Review of Methodology for Proposed Retention of Cadbury Building Façade

The purpose of this letter is to transmit the outcomes of our review (on behalf of Dunedin City Council) of technical assessments (completed by others) of the retention of the existing Cadbury building façade and incorporation into the construction of the proposed Dunedin Hospital development.

- LUC-2020-263 Appendix 6 Structural – Addendum: New Dunedin Hospital – Engineering Assessment of Existing Facades (WSP 2020)
- LUC-2020-263 Appendix 12 Cost – Addendum: New Dunedin Hospital, Façade Retention Option Estimates (Rider Levett Bucknall 2020)

Figure 2, Option 2A Support to the façade where the façade is physically separated from the new building

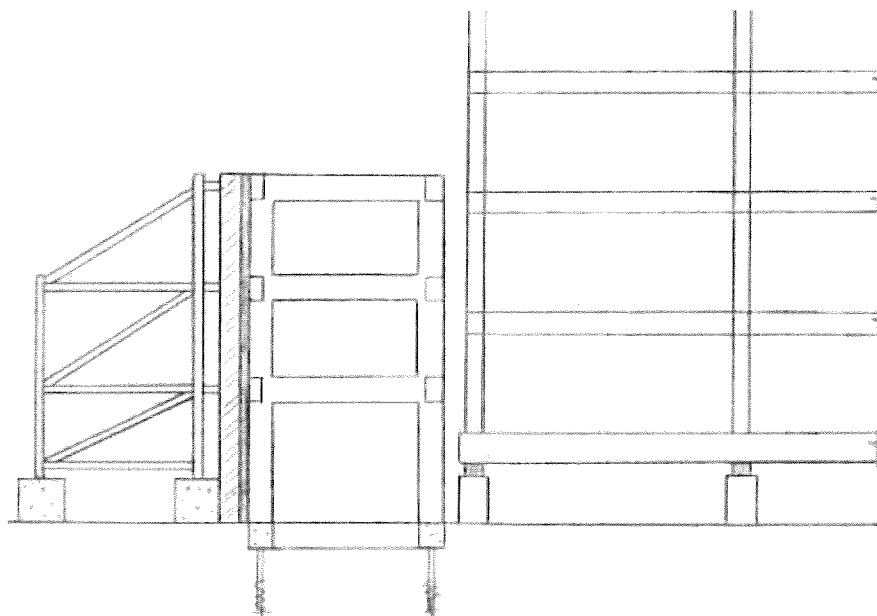
Much of the initial WSP report is redundant as revised layout results in the façade being physically separated from the new hospital buildings. Thus, much of the façade will require independent support in a similar manner as option 2A shown above. The façade is narrow, brittle, heavy, delicate and high and thus a substantial piled structure will be required to capture and support the façade against wind and seismic loading.

As sketched in option 2A above, support of the facade would require its own independent support and foundation system. This would require a significant permanent structural frame to support and hold the façade. At least two rows of piles would be required to support the permanent support frame, one inside the façade and a second row of piles along the outside of the support frame. This would in turn require the temporary frame to be on the outside of the façade so that there was sufficient space inside the façade to demolish the existing building and construct the permanent support structure. As noted in the WSP report an external temporary support frame is possible but it would conflict with the trafficable lanes. We believe that this temporary support frame may also require piles and there is a risk of the piles clashing with the existing underground services. WSP's sketches show the temporary framing to only have strip footings, however piles may be required for this frame. There is no single drawing showing sections showing all of the underground services outside the façade, but a look at the service drawings indicates that constructing the piles to support the temporary support frame would be difficult around the existing services.

Both the temporary and permanent support frame for the façade are likely to require a piled foundation. Piles are not shown below the temporary support frames on the option sketches reproduced earlier in this letter.

Figure 3 Option 1A where the façade is incorporated into the new building along with its associated base isolation.

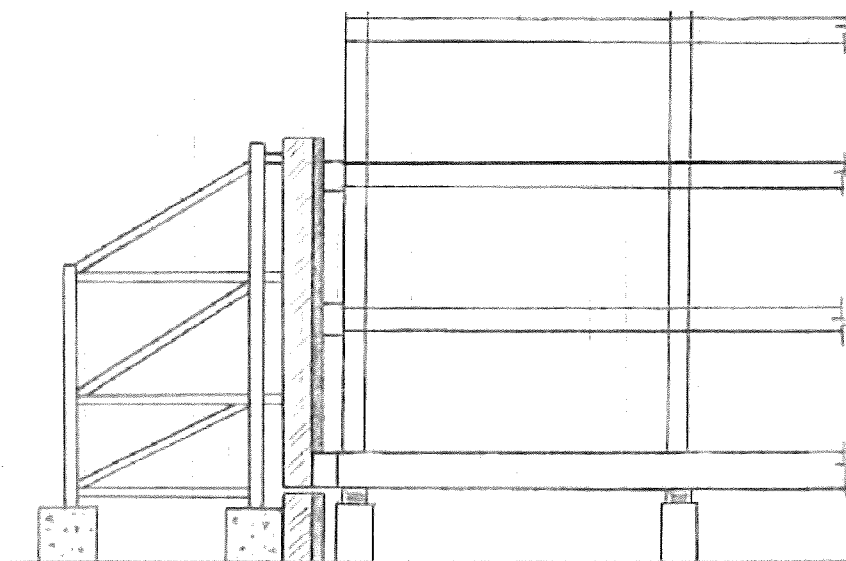
Where the façade is incorporated into the building, it will need to be incorporated into the base isolation of the building as per WSP Option 1A as it will need to move with the new building under seismic loads. As a result, the part of the façade which if fixed will need to be physically separated approximately 500mm from the part of the façade which is incorporated in the new building. While this is technically possible it not likely to be attractive and it adds significant challenges to support the façade at the point of separation.
